Access Compliance Report

Public Rights-of-Way

Intersection ID: 15201	Main Street: ALBEMARLE_RD	Cross Street: LAWYERS_RD	Location: NE
ADA ID: 26CF80AD1BCF	Ramp Type: Perp	Initial Pass/Fail: Fail	Overall Compliance: No
			Severity Score: 21.25

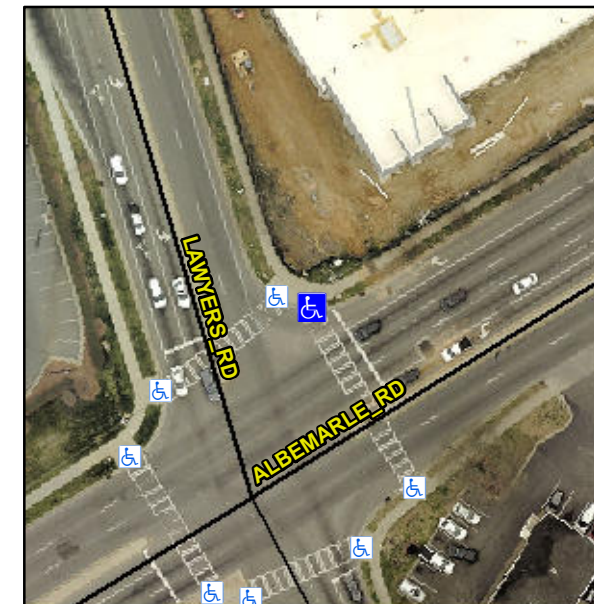
Not Found, R304.5.1, R304.2.2

Compliance	Description	Data	Compliance	Description	Data
N/A	Ramp Length (in)	86.0	No	Ramp Slope (%)	8.5
No	Ramp Width (in)	46.5	Yes	Ramp XSlope (%)	0.5
N/A	Flare Type LT	N/A	N/A	Flare Type RT	N/A
N/A	Flare Slope LT (%)	N/A	N/A	Flare Slope RT (%)	N/A
N/A	Flare Traversable LT?	N/A	N/A	Flare Traversable RT?	N/A
N/A	Landing Length (in)	N/A	N/A	DWS Provided?	N/A
N/A	Landing Width (in)	N/A	N/A	DWS Contrast?	N/A
N/A	Landing Slope (%)	N/A	N/A	DWS Length (in)	N/A
N/A	Landing X Slope (%)	N/A	N/A	DWS Full Width?	N/A
N/A	Landing Curb? (Y/N)	N/A	N/A	DWS Offset (in)	N/A
N/A	Shared Landing?	N/A			
N/A	Gutter Ponding?	N/A	N/A	Gutter Slope (%)	N/A
N/A	Gutter Lip Ht (in)	N/A	N/A	Gutter X Slope (%)	N/A
N/A	Painted X Walk1?	Yes	N/A	Painted X Walk2?	N/A
	X Walk 1 Direction	To SE		X Walk 2 Direction	N/A
N/A	X Walk 1 Width (in)	121.0	N/A	X Walk 2 Width (in)	N/A
	X Walk 1 Slope (%)	2.7		X Walk 2 Slope (%)	N/A
	X Walk 1 X Slope (%)	1.2		X Walk 2 X Slope (%)	N/A

Remove & Replace Entire Ramp.
